CAPACITOR FOR MOTOR INSIDE OF HOSE ASSY

NAME OF GAME: BRAVE FIRE FIGHTER

April 12th, 2007

FIG.1 □ NEW MOTOR
(with Capacitor that inside of cap)

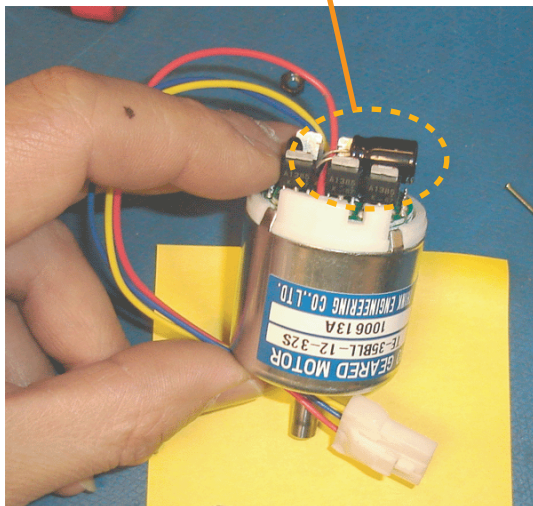
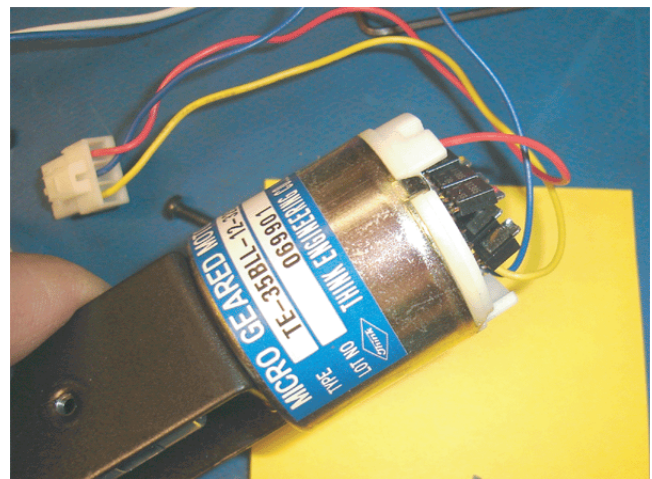
PLEASE REMOVE CAPACITOR (See Fig.3) WHEN YOU RECEIVE NEW MOTOR ASSY FOR MAINTENANCE PARTS FROM US BECAUSE NEW MOTOR ALREADY INCLUDE CAPACITOR INSIDE OF MOTOR. (SPEAKER MAKES POP NOISE AND SOUND DROPS)

FIG.3 □ INSIDE OF HOSE ASSY MOTOR
(Capacitor on harness)

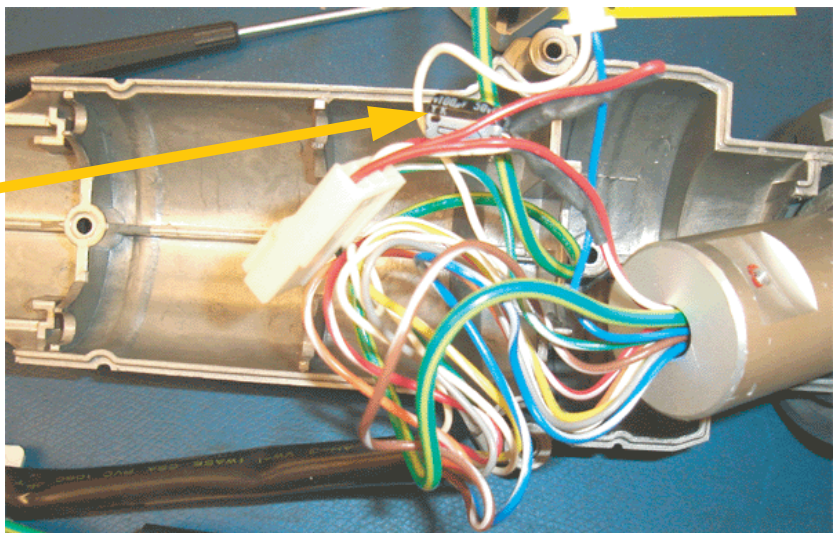
PLEASE REMOVE THIS CAPACITOR ON HARNESS WHEN YOU EXCHANGE TO NEW MOTOR.
